Pacific Sardine Stock Assessment Review Panel Meeting Report

NOAA / Southwest Fisheries Science Center
La Jolla, California
February 24-27, 2020

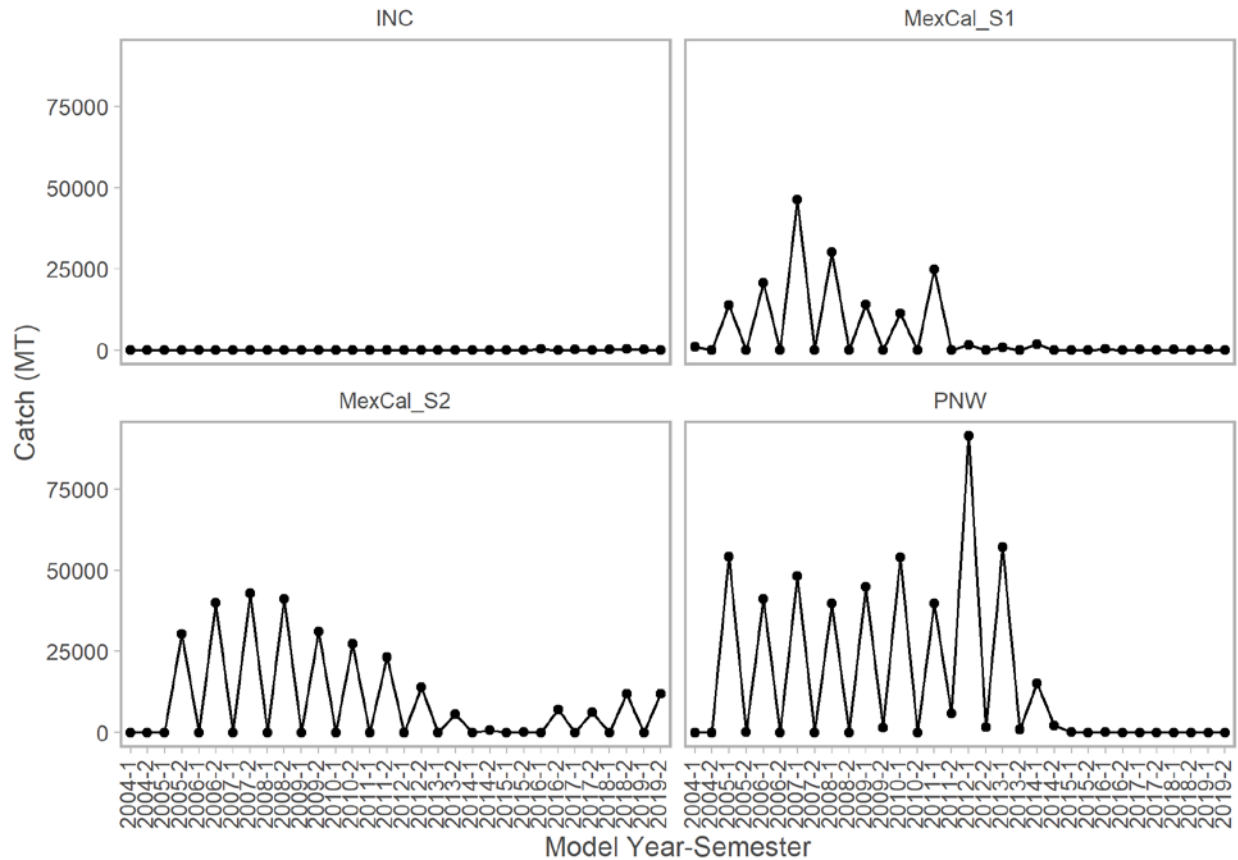
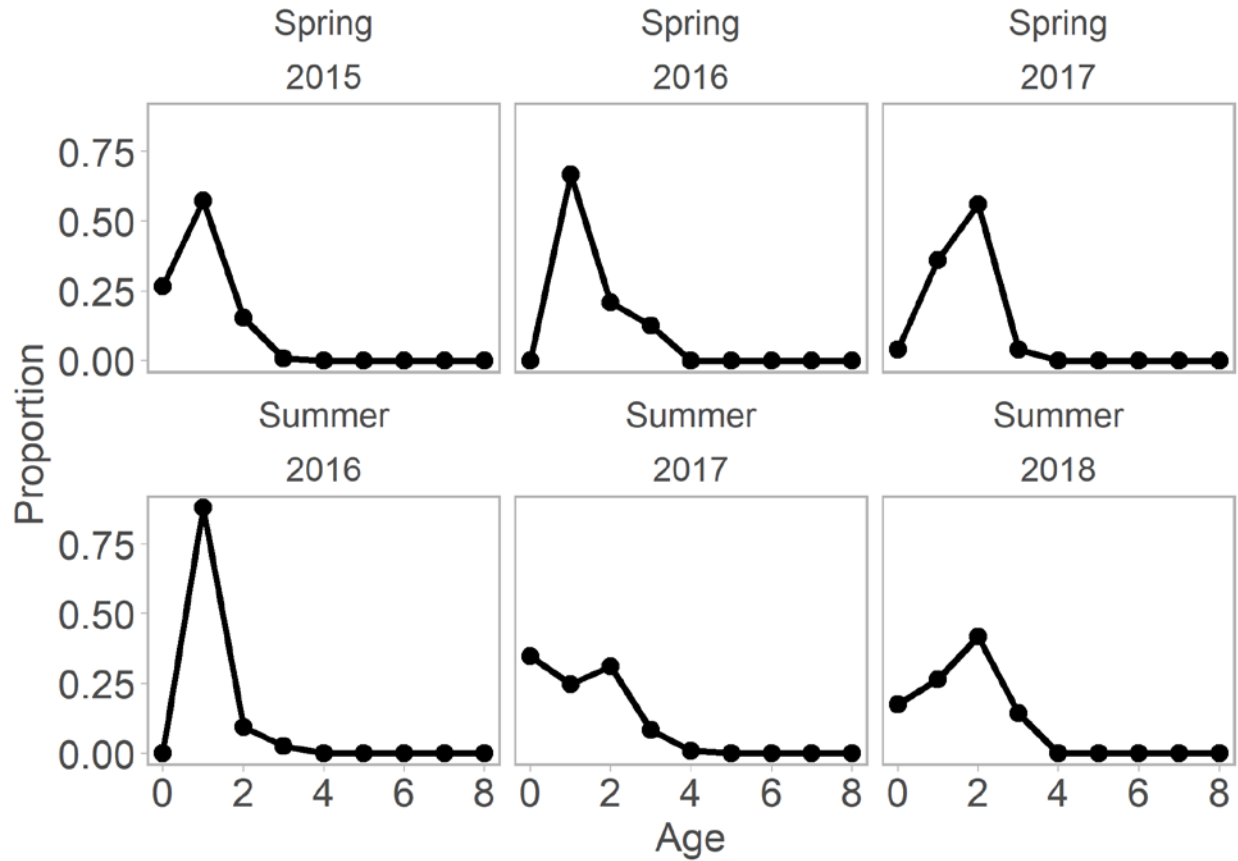
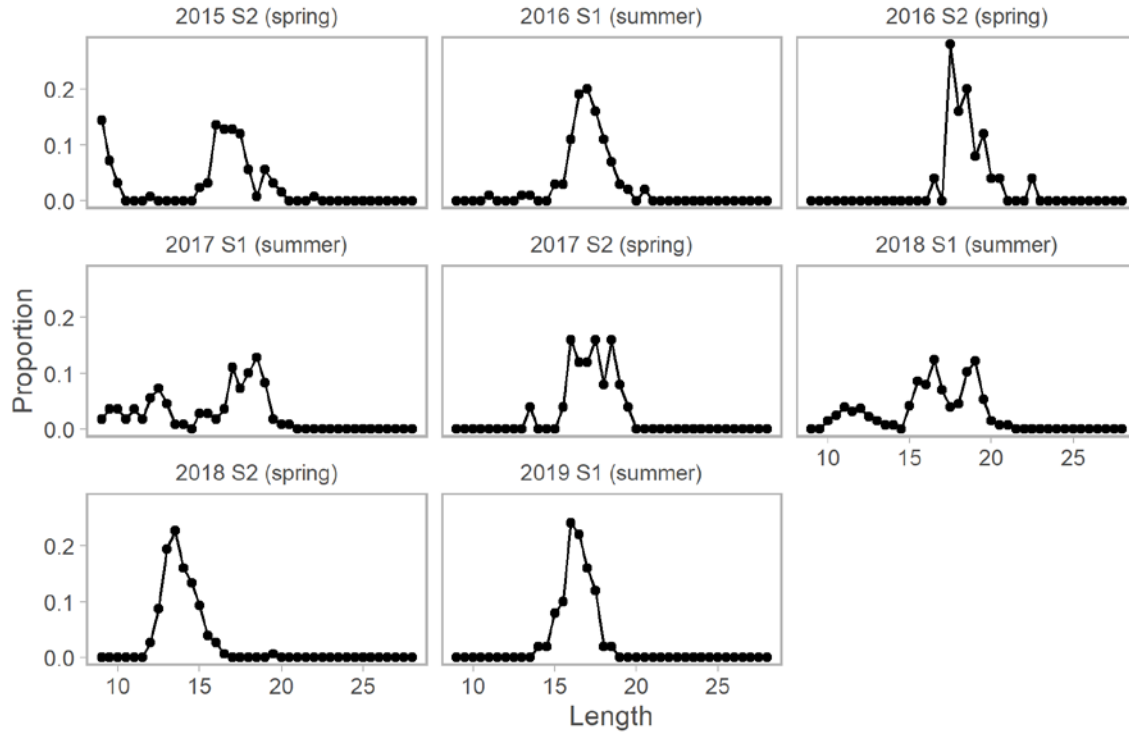
Request 1: Provide a plot of the catches and age- and length-compositions for the non-directed fishery (NDF).

Rationale: These data are included in a model sensitivity run but are not shown in the document.

Response: The STAT provided the requested figures. The following figure shows the 2005 to 2019 catches. The incidental catches (INC) largely come from the MexCal region.

The following figure shows the INC age compositions (note that age-compositions are not available for spring 2018 and summer 2019) [The year refers to the model year (i.e. “Spring 2015”

The following figure shows the INC length compositions. The number of model year-semester with length compositions was greater than the number with age compositions. Not all the incidental

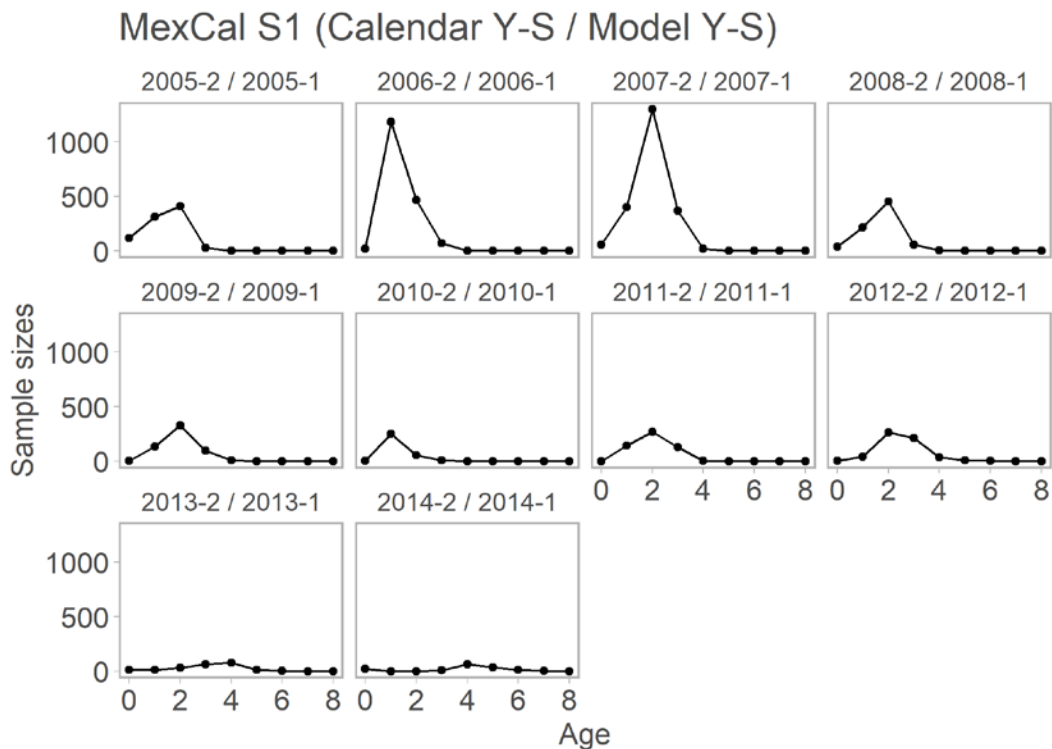
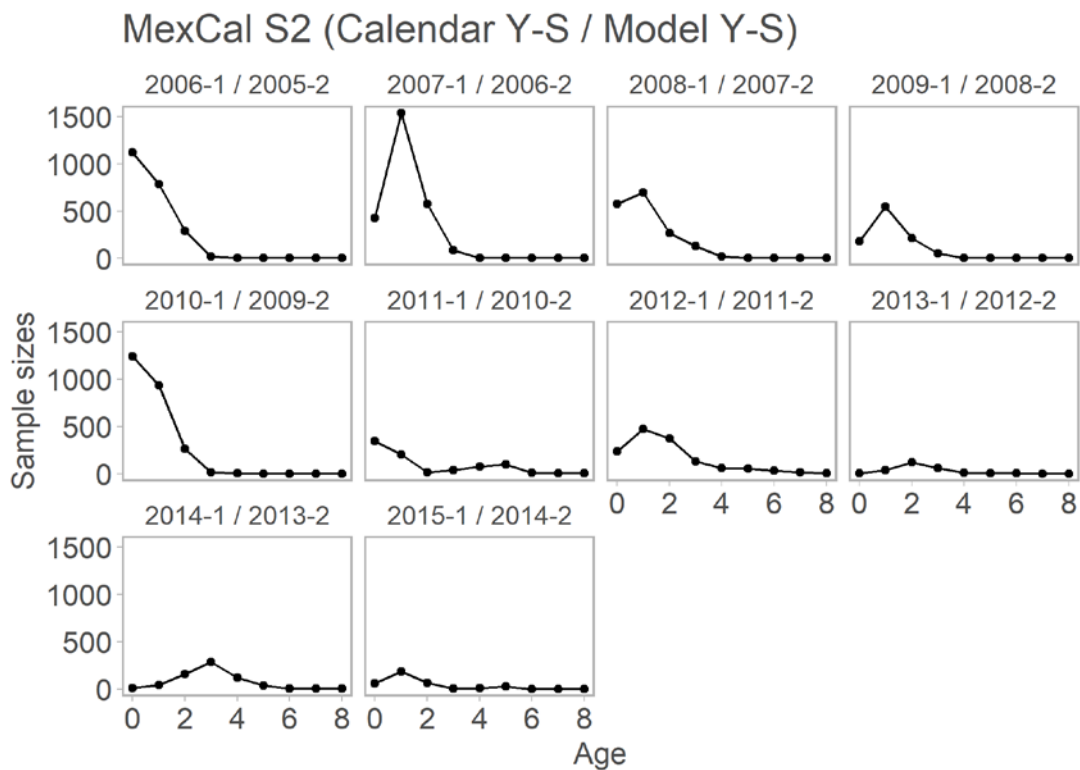
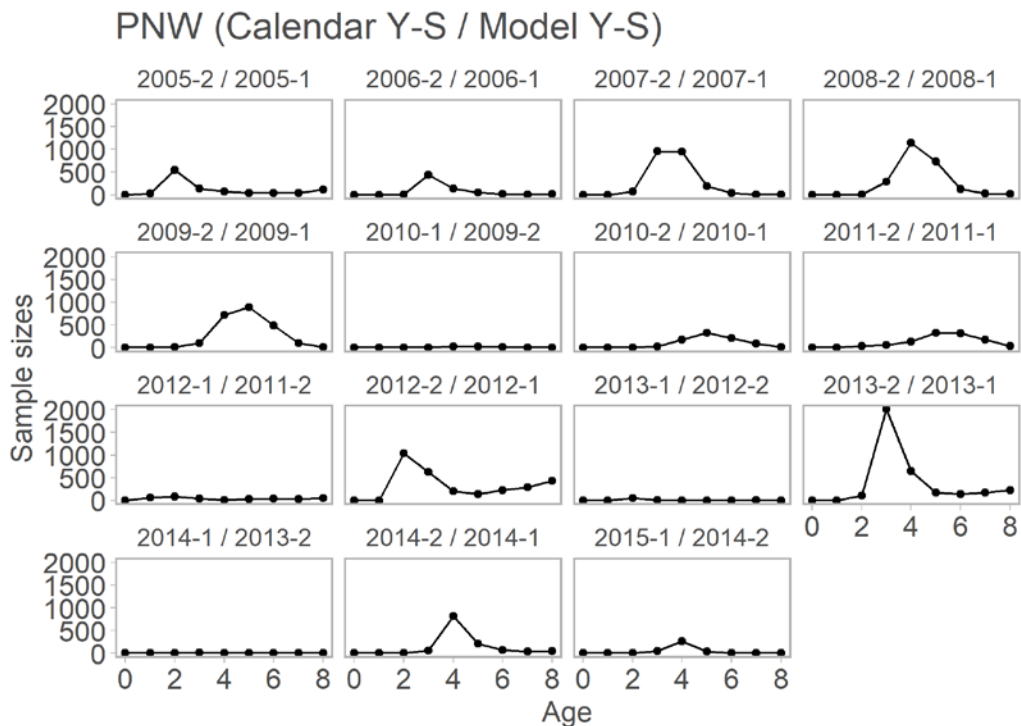
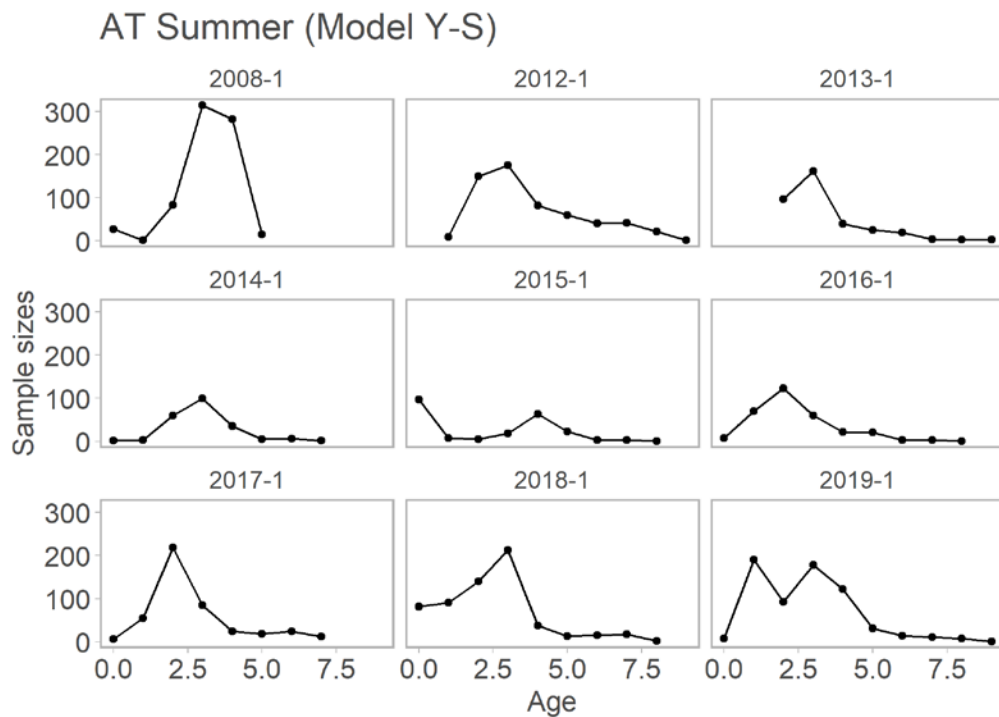
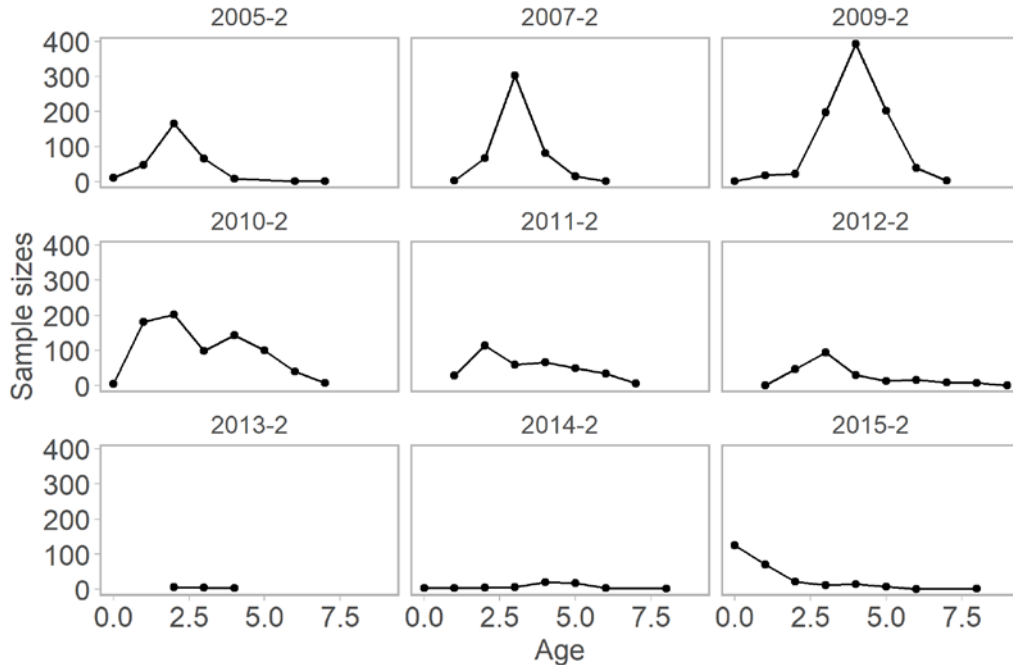
Request 2: Add sample sizes to the weight-at-age plots for all fleets and surveys (or create a table).

Rationale: The weight-at-age by cohort has odd behaviour at older ages in some years; this may be due to small sample sizes.

Response: There are very few samples for ages beyond 4-5 because fish of these ages are not frequently observed (MexCal S1 and S2). The PNW sample sizes are larger at older ages in some, but not all, years. The AT samples have larger sample sizes for older ages (up to about age 7) in some, but not all, years.

The following figure shows the weight-at-age sample sizes for the MexCal summer fleet.

The following figure shows the weight-at-age sample sizes for the MexCal spring fleet

The following figure shows the weight-at-age sample sizes for the PNW fleet.

The following figures show the weight-at-age sample sizes for the acoustic trawl survey.

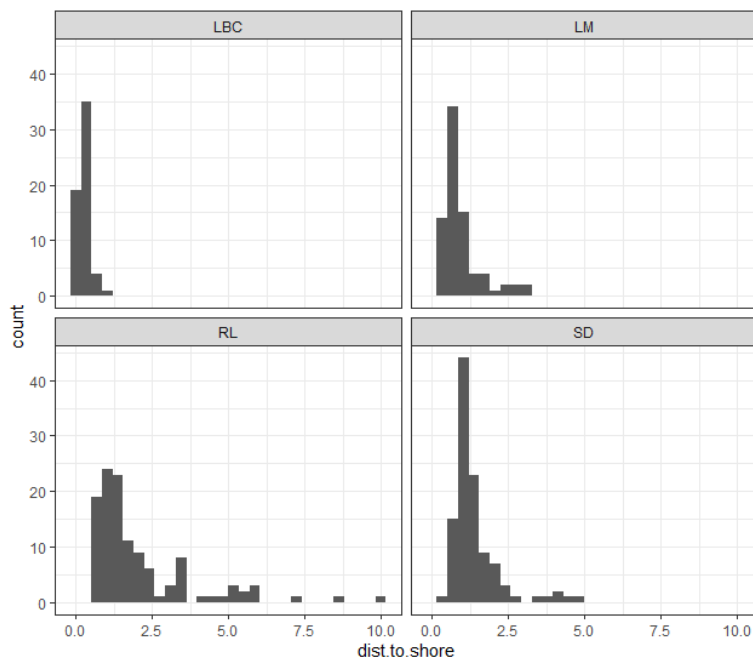
Request 4: Provide a table that shows the nearshore extent of each survey method (acoustic trawl, sail drone, commercial vessel, and aerial survey).

Rationale: The Panel wished to better understand each survey region and the extent to which the area covered by each survey type overlaps.

Response: The following figure of the count of point set distances from the coast was provided (LBC=Long Beach Carnage, LM=Lisa Marie, RL=Reuben Lasker, SD=sail drone) for 2019. It was noted that the LBC (nearshore acoustic survey using the fishing vessel *Carnage*) and the CCPSS could overlap in southern California. However, the CCPSS data in this assessment were collected from north of Point Conception. The question of whether the sail drone and CCPSS overlap spatially was raised, but it was concluded that any overlap was minimal because most sardine observations are in the most nearshore band of the CCPSS.

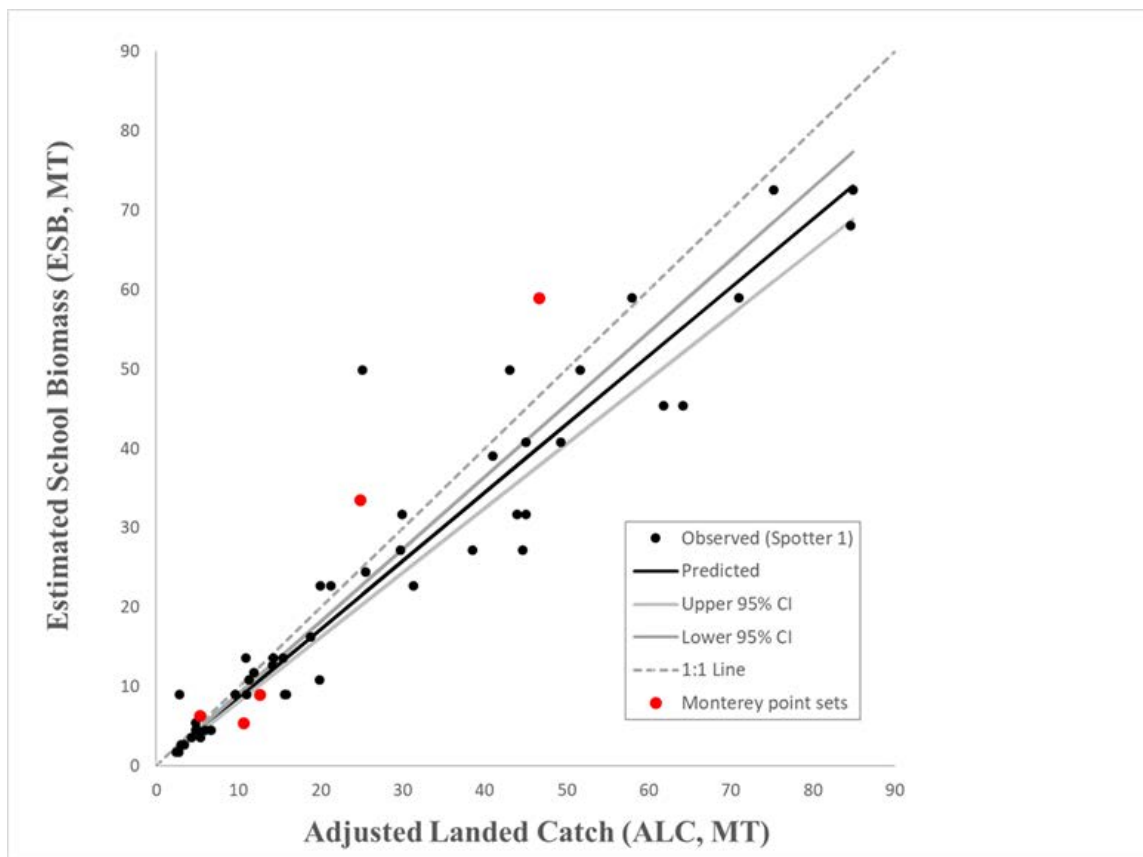
Request 7: Plot the point set data for the aerial survey showing the observer estimates and landed catches.

Rationale: The Panel wished to better understand how visual estimates from observers compare to captured biomass. What proportion of the visually estimated biomass is covered by the catch data?

Response: The following figure of adjusted landed catch and estimated school biomass was provided. The plot confirms good estimation of school size biomass up to about 100 mt.

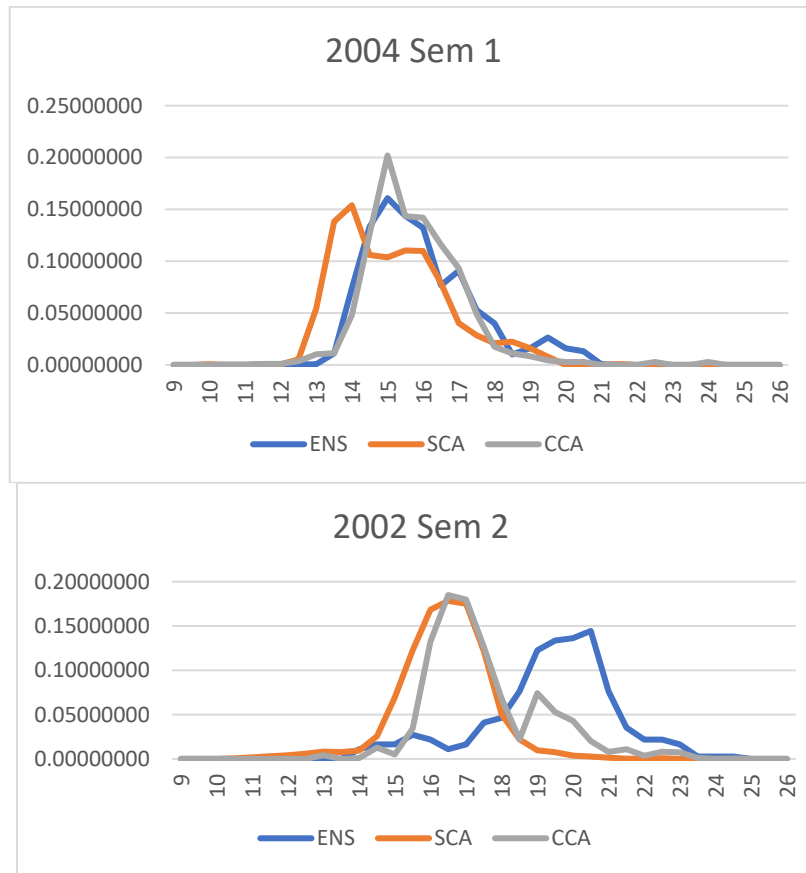
Request 10: This request follows from Request 5. Verify that ages are similar for Mexico and California by showing the length frequencies for each fleet.

Rationale: This is important because there are no Mexican age data and this comparison serves as a test of the assumption that California ages are representative of Mexico.

Response: Data show that Ensenada lengths are typically similar or larger than those from California. However, the data are variable, rather than being systematically different. It was noted that it would be beneficial to get age data from Mexico in the future, which would require coordination of methods between ageing labs. Example comparisons of the proportion of the catch by region in each 0.5cm length class are provided below.

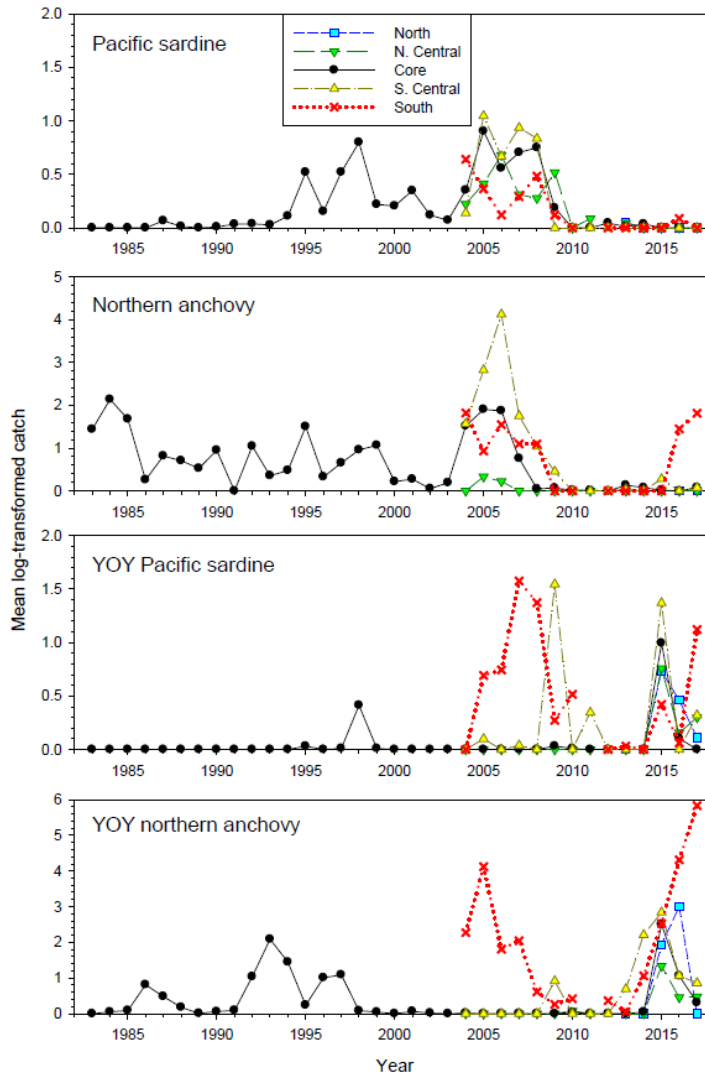
Request 13: Get and plot sardine data for the juvenile rockfish survey, including the index and composition data (if available).

Rationale: The juvenile rockfish survey may provide information in recruitment not currently in the model.

Response: The following figure from the 2017 cruise report shows that there was a spike in 2015 in young of year (YOY – age 0) Pacific sardine but not adult (age 1+) Pacific sardine. See also the response to Request 16, which shows positive recruitment deviations in 2016 and 2017, suggesting that the data from the juvenile rockfish survey may be capable of detecting recent recruitment events. This survey could not be included in the assessment because it has not been subject to a methodology review.
